## SUMMARY AND RECOMMENDATION

**1 REZONING:** a) 1262-1290 Burrard Street and b) 1229-1281 Hornby Street

**Summary:** To rezone a) 1262-1290 Burrard Street from DD (Downtown District) to CD-1 (Comprehensive Development) District to permit a mixed-use building with retail, service and office uses. A floor area of 19,715.4 m<sup>2</sup> (212,222 sq. ft.) and a maximum height of 55.5 m (182 ft.) are proposed.

To rezone b) 1229-1281 Hornby Street from DD (Downtown District) to CD-1 (Comprehensive Development) District to permit a mixed-use development including two residential towers connected by a podium, with market strata and rental residential units and office, retail and service uses. A floor area of 67,430 m<sup>2</sup> (725,837 sq. ft.) and a maximum height of 167.6 m (550 ft.) are proposed.

Figure 1

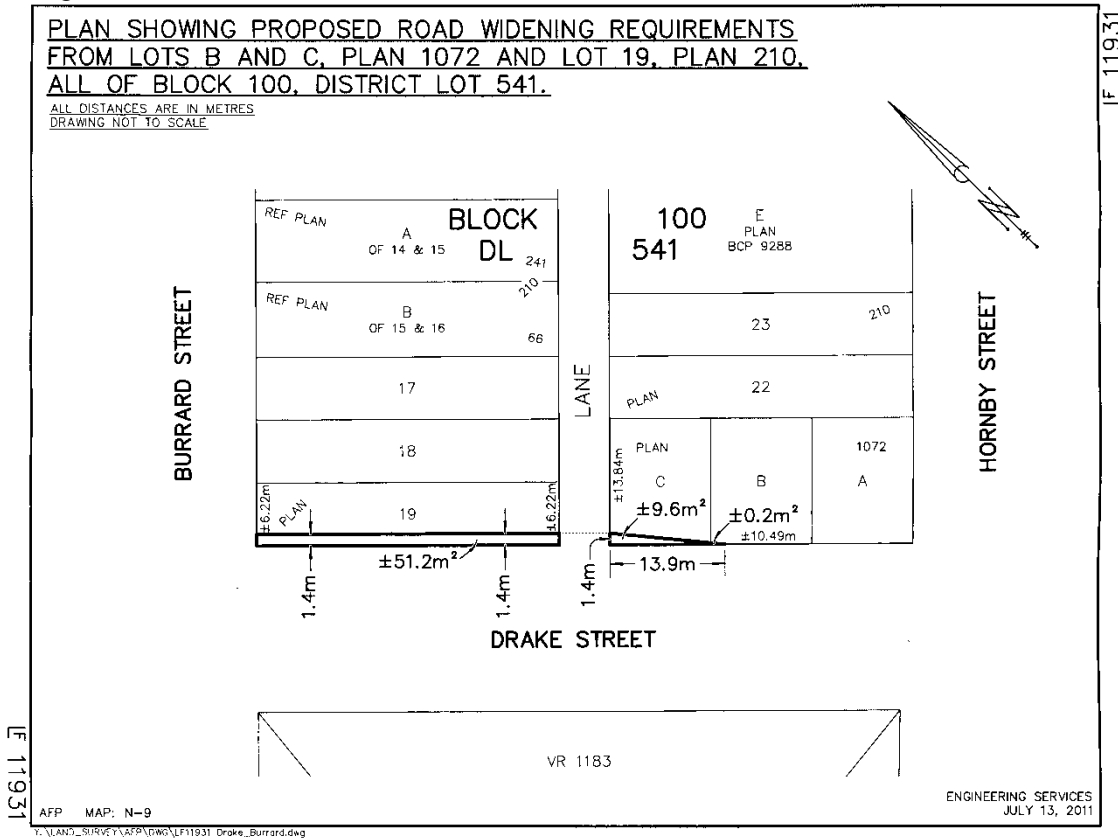
1. Consolidation of Lots 11 to 13, N1/2 of 14, A (Reference Plan 241) of Lots 14 and 15, B (Reference Plan 66) of Lots 15 and 16, and Lots 17 to 19, all of Block 100, DL 541, Plan 210 to create a single parcel.
2. Provision of surface statutory rights of way for public access and road purposes over the southwesterly 1.4 metres of the site from Burrard St. to the lane, adjacent to Drake St; and over the southwesterly part of the site defined by a point measured 1.4 metres along the existing northwesterly property line from Drake street, and a point measured 13.9 metres along the southwesterly property line from the lane (see Figure 1).

Diagram 1

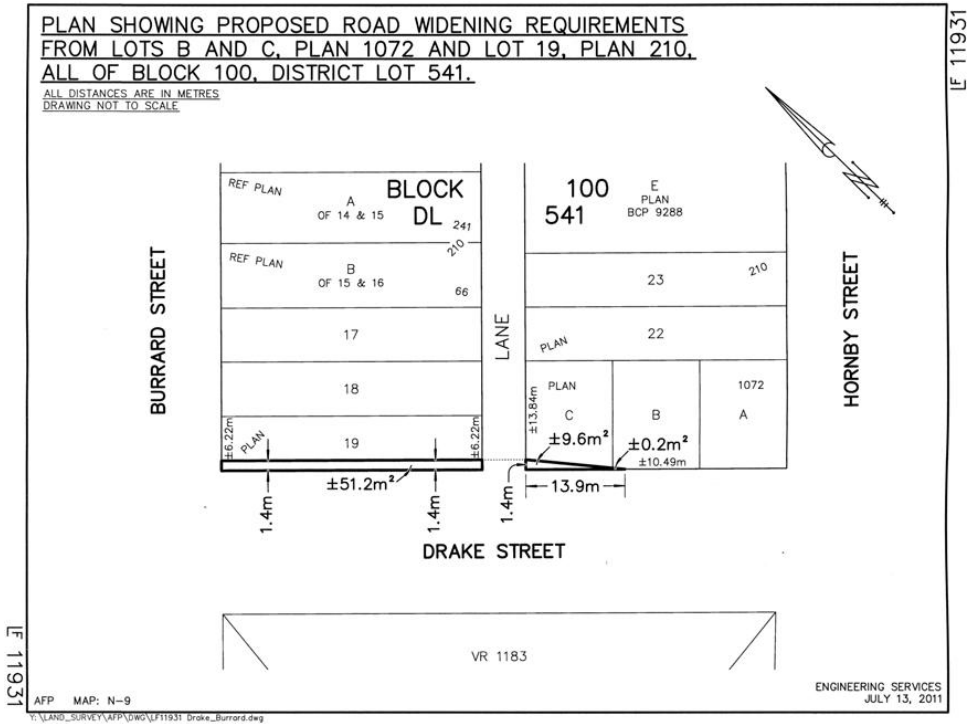
1. Consolidation of Lots 22, 23, and 26 to 33, Plan 210; Lots A, B, and C, Plan 1072; and Lot E, Plan BCP9288; all of Block 100, DL 541 to create a single parcel.
2. Provision of surface statutory rights of way for public access and road purposes over the southwesterly 1.4 metres of the site from Burrard St. to the lane, adjacent to Drake St; and over the southwesterly part of the site defined by a point measured 1.4 metres along the existing northwesterly property line from Drake Street, and a point measured 13.9 metres along the southwesterly property line from the lane (see Diagram 1)
